**NOTICE OF ADDENDUM
ADDENDUM NO. 2**

**CONTRACT NO. 7939
MADISON MUNICIPAL BUILDING - RENOVATION**

This addendum is issued to modify, explain or correct the original Drawings, Specifications, or Contract Documents and is hereby made a part of the contract documents.

1 LEVEL 3 W16 - HEAD DETAIL
A651 3" = 1'-0"

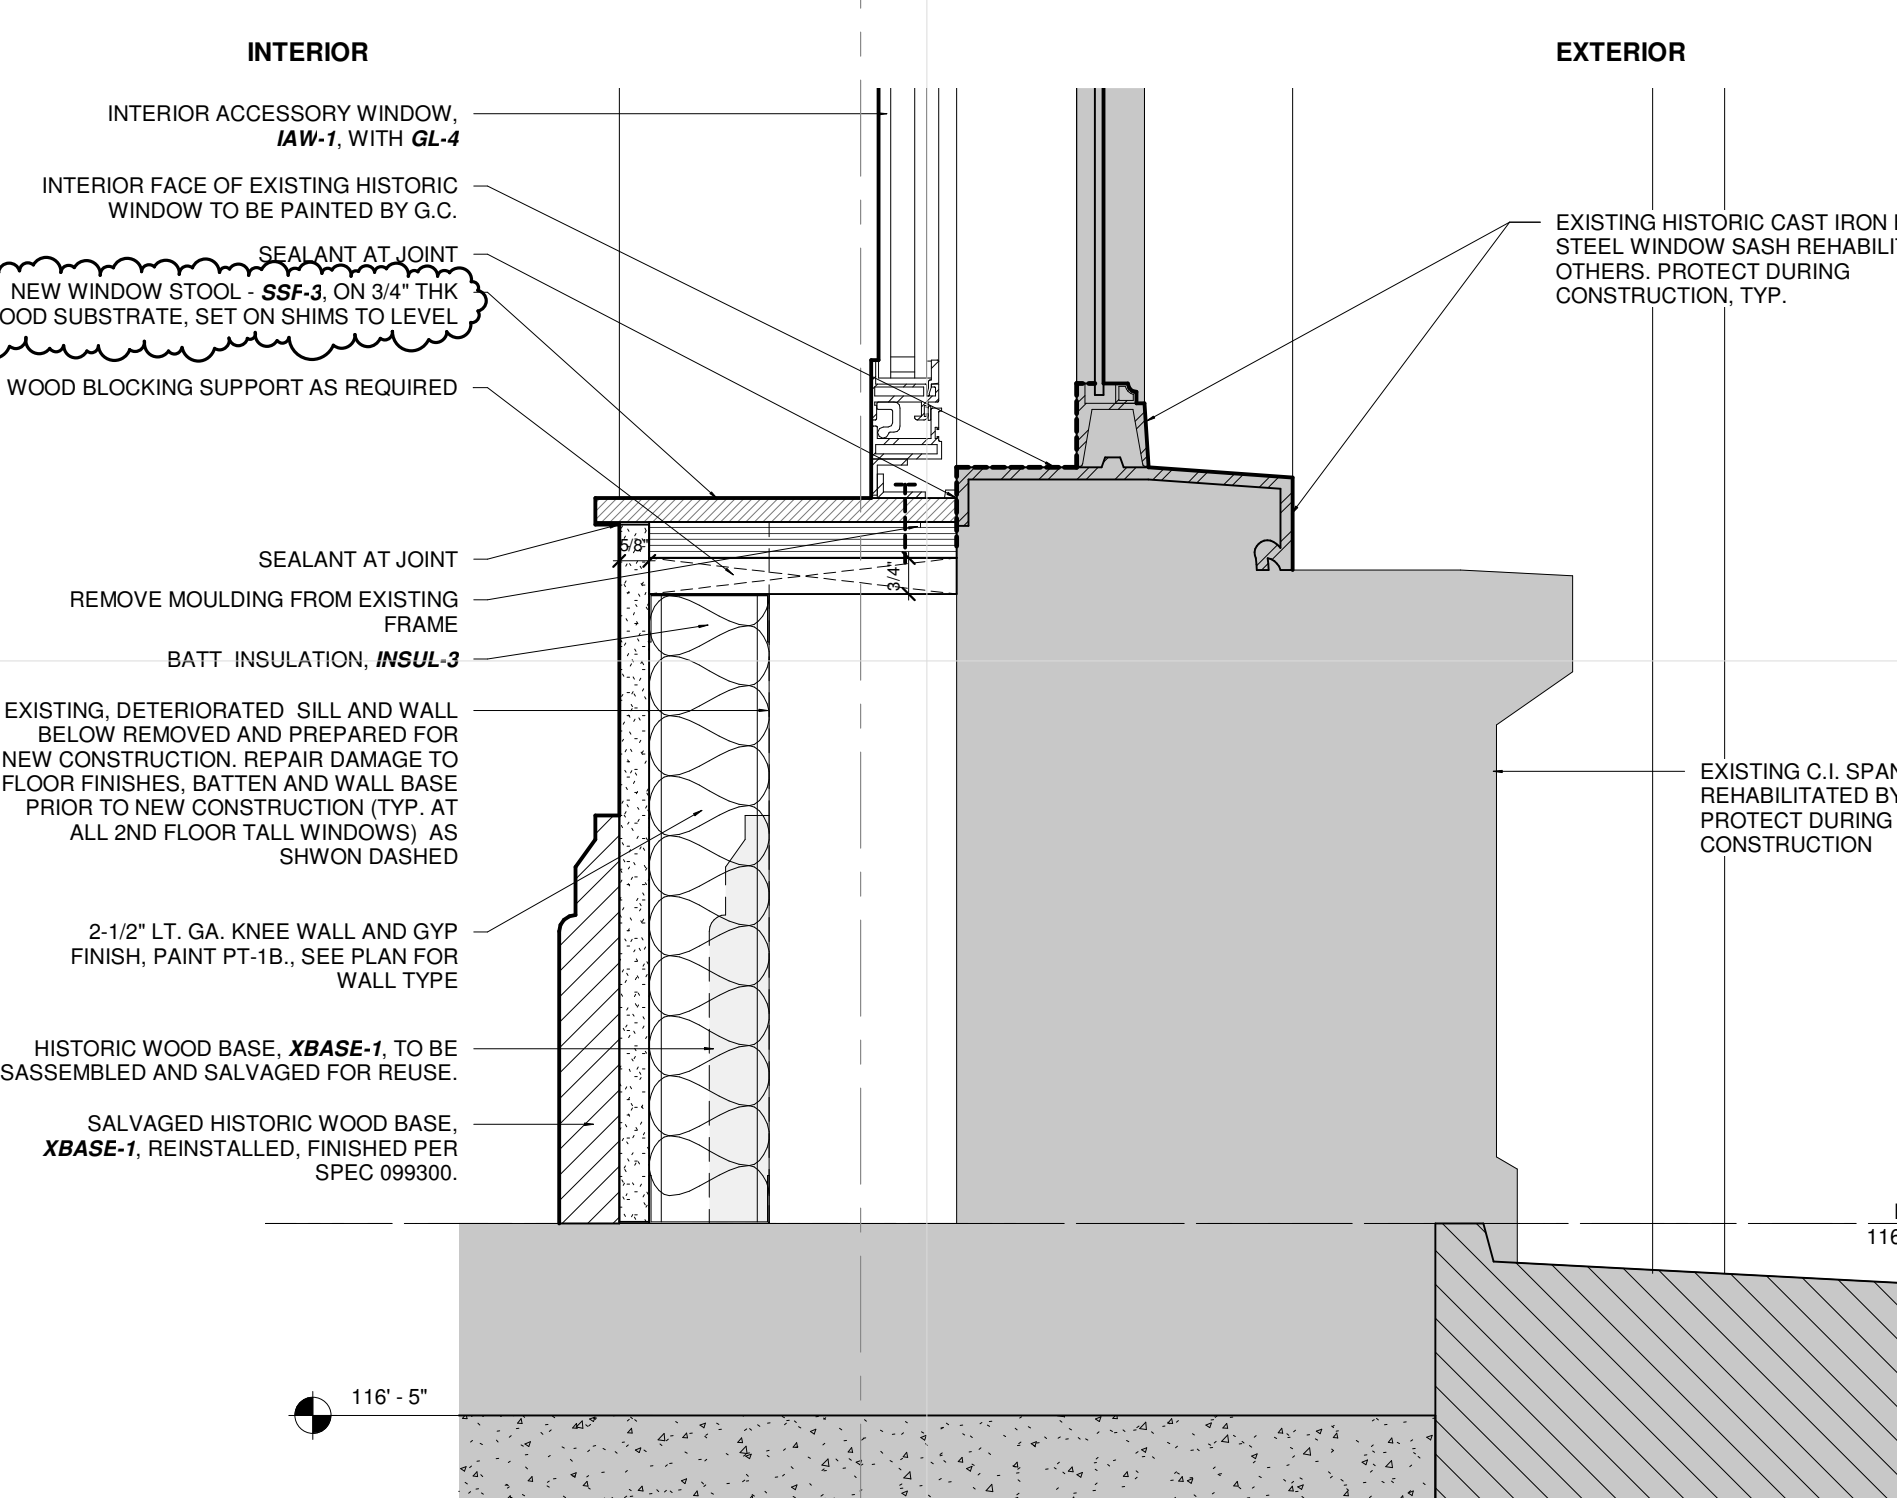
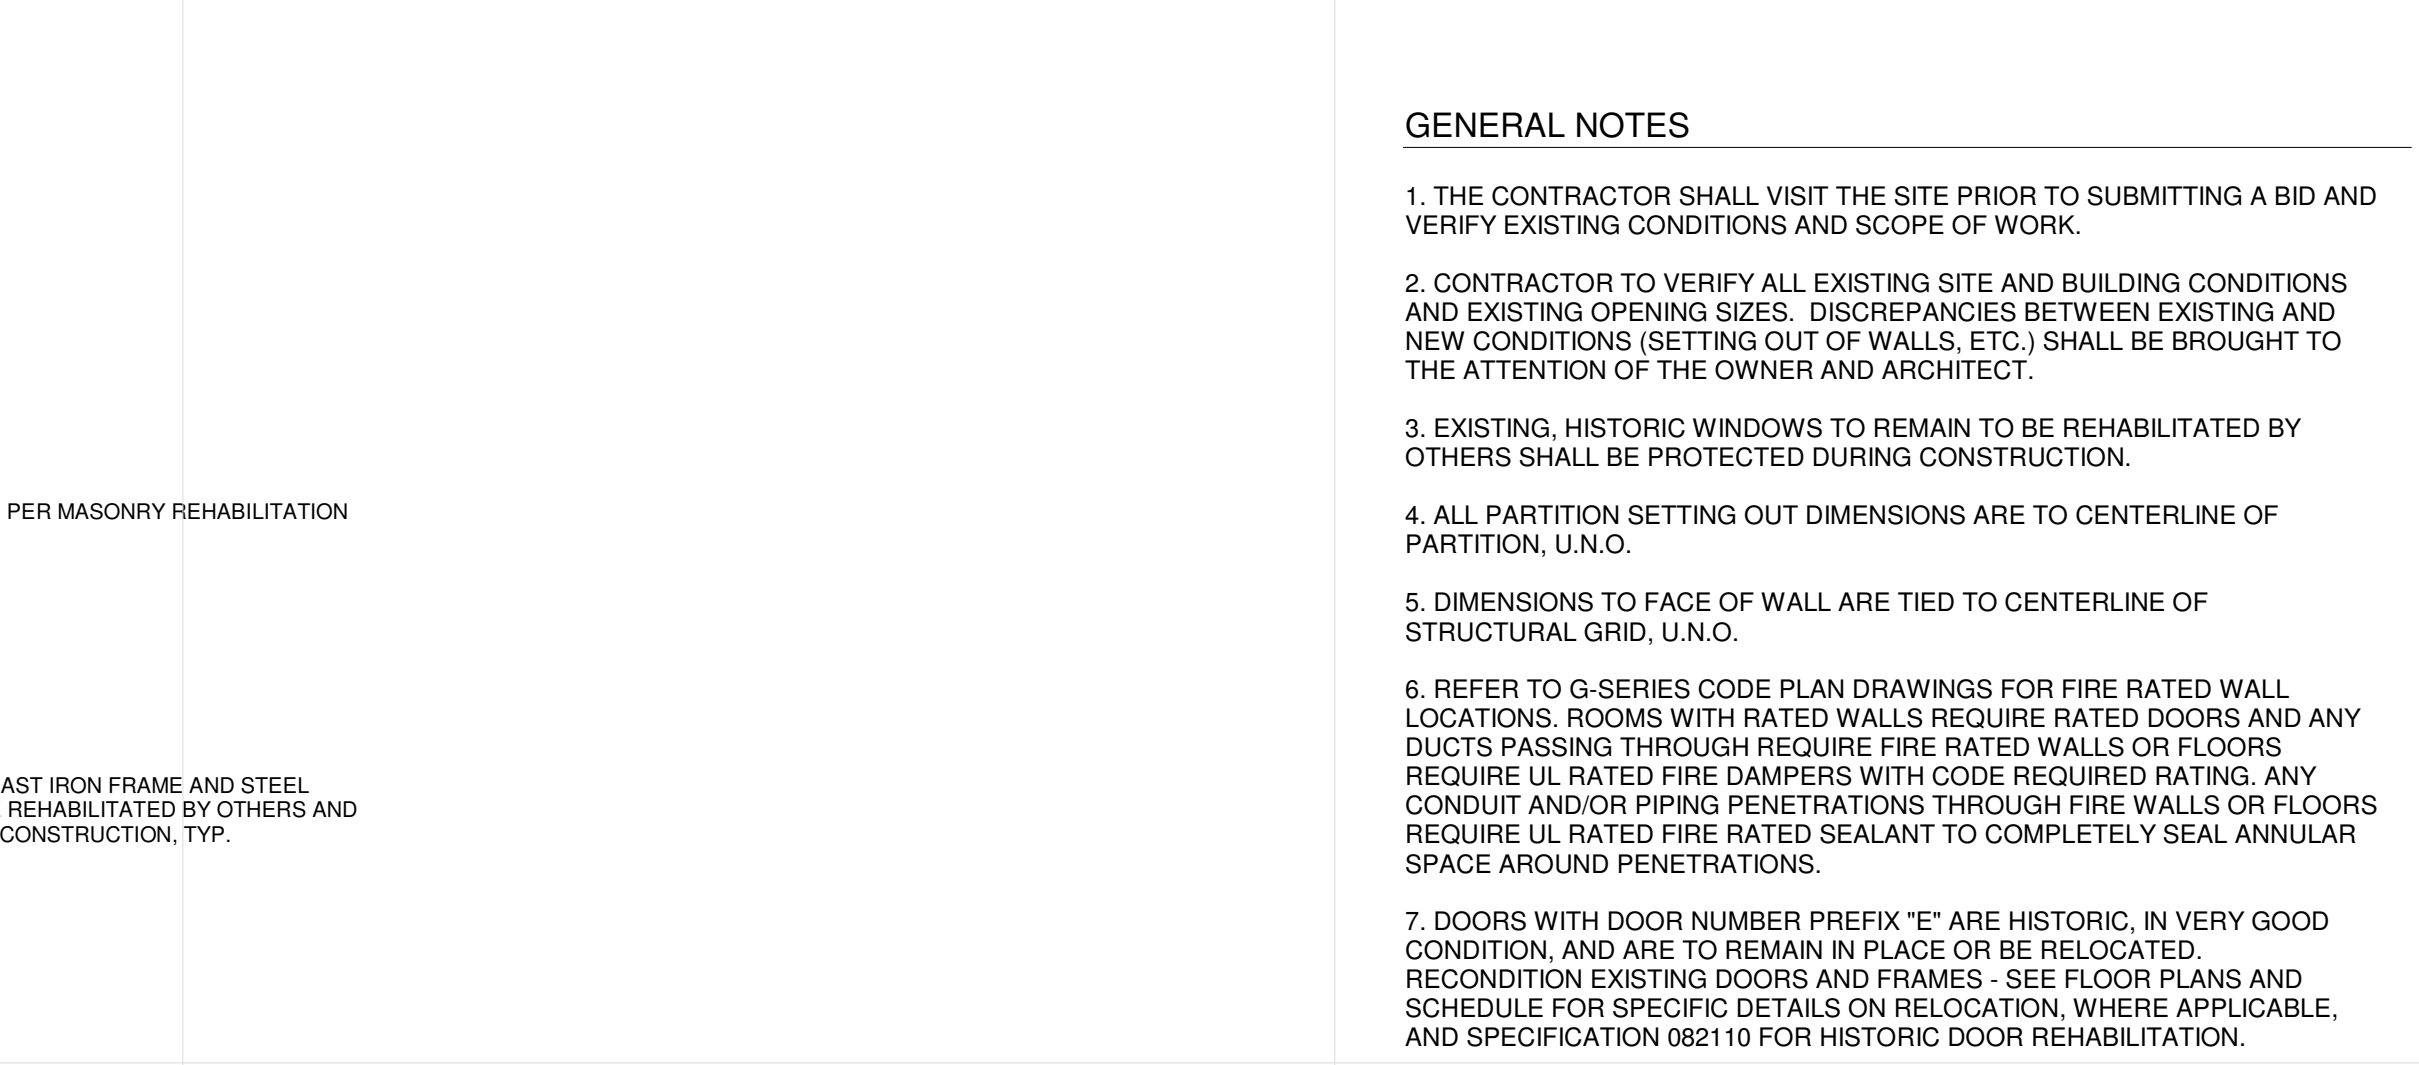
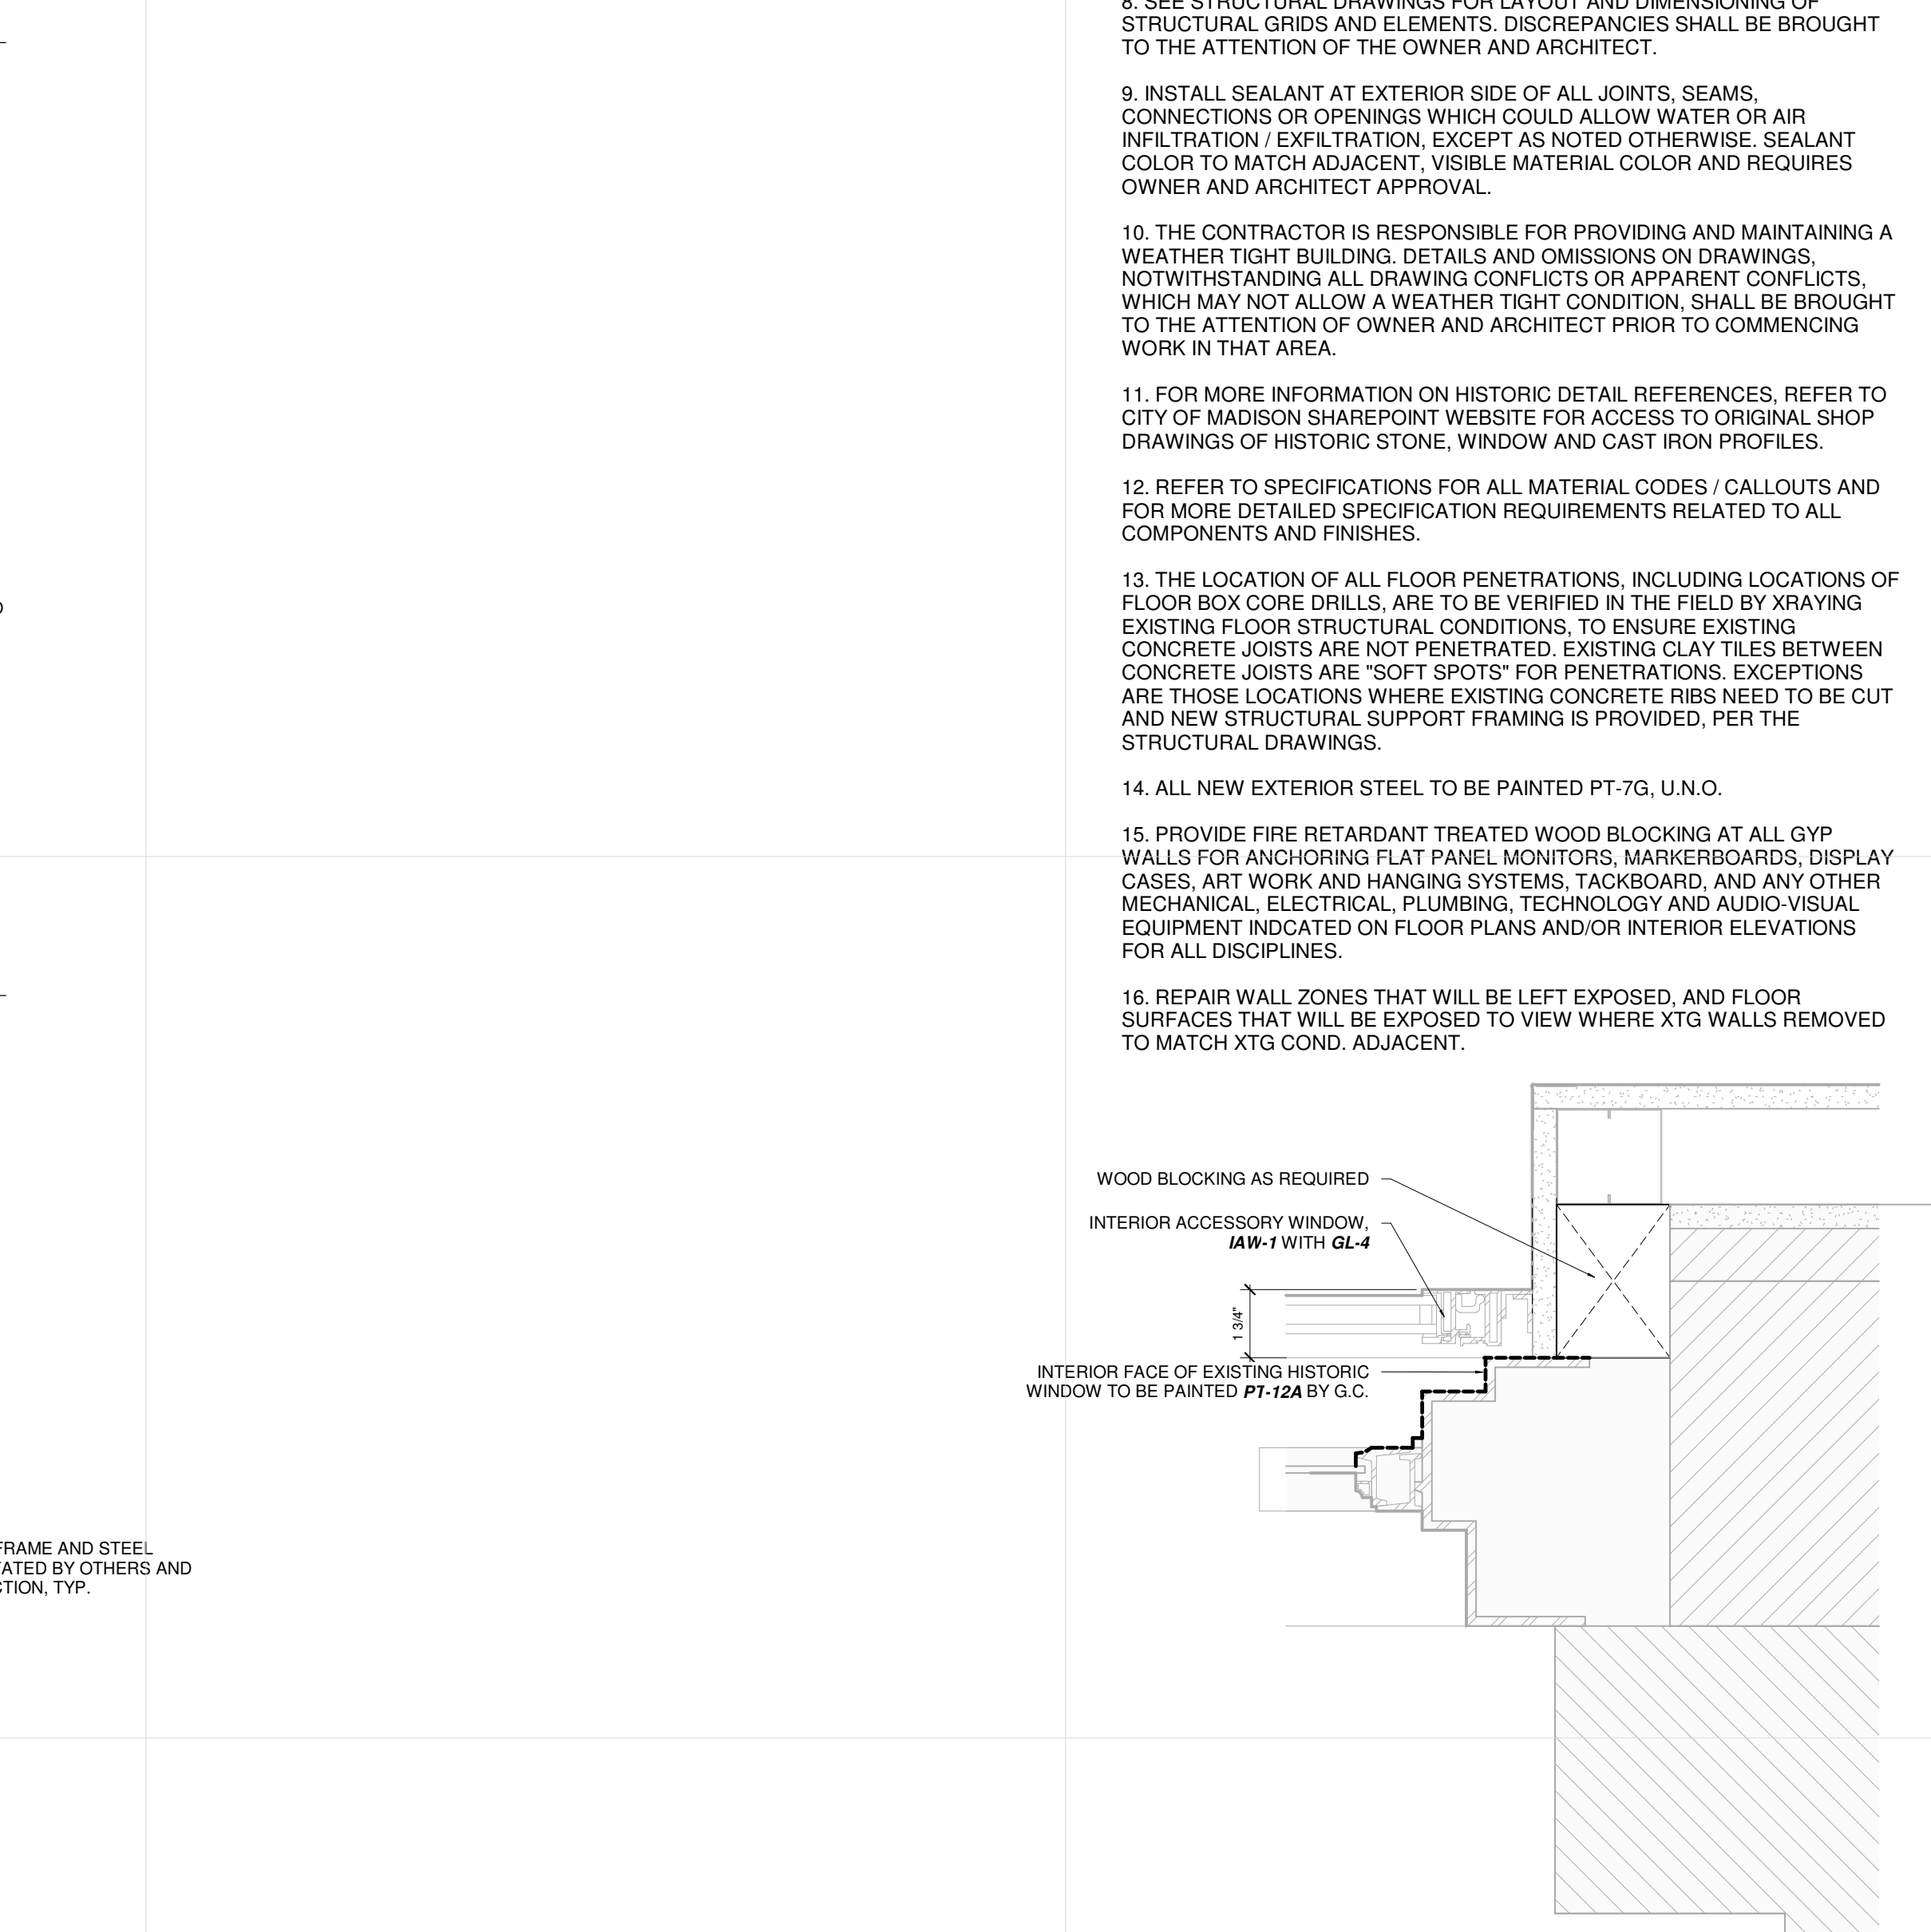
4. Details A620 through A624, and A651 through A654. Due to durability and cost concerns regarding the new metal window stools, these have been changed from MTL-3 to solid surface material SSF-3.
5. BE001. Amend general note 10 on sheet BE001 (drawing); Add language to general note 16 on sheet BE001 (drawing)
6. BE219. Revised stone numbers
7. BE338. See Clarifications Section below
8. BE356. See Clarifications Section Below
9. BE356.1. See Clarifications Section Below
10. BE356.2. See Clarifications Section Below
11. S101. See Structural Memo Attached.
12. S102. See Structural Memo Attached.
13. S103. See Structural Memo Attached.
14. S104. See Structural Memo Attached.
15. S190. See Structural Memo Attached.
16. S201. See Structural Memo Attached.
17. S302. See Structural Memo Attached.
18. S304. See Structural Memo Attached.
19. E300. See MEP Memo Attached.
